To: Ariel Wessel-Fuss
Subject: RE: Harpeth Conservancy comment on Proposed Small MS4 General Permit, TNS000000

Re: Comments on Proposed Small MS4 General Permit, TNS000000

**PETITION FOR APPEAL OF NPDES PERMIT NO. TNS000000, SMALL
MUNICIPAL SEPARATE STORM SEWER SYSTEMS**

Figure 21: Residential Rooftop Disconnection to downstream raingarden – Bioretention without an underdrain (Source: VADCR).³⁰

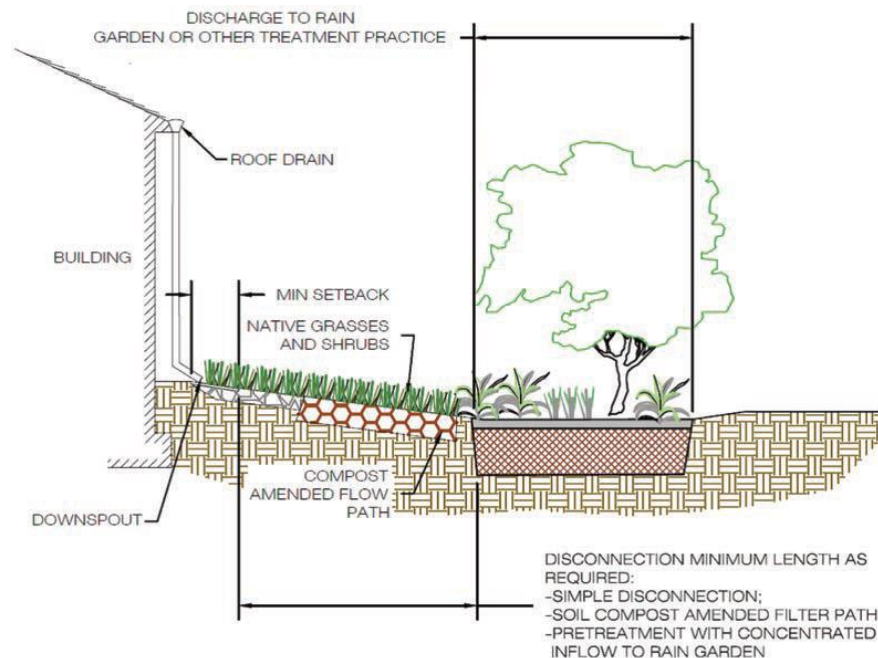
By making the subject exclusion in the current Permit discretionary, TDEC also implicitly acknowledges that roof runoff can still be practicably treated. For if an MS4 chooses not to utilize the exclusion, developers will be required to incorporate roof runoff into their WQTV and SCM calculations as they have in the past.
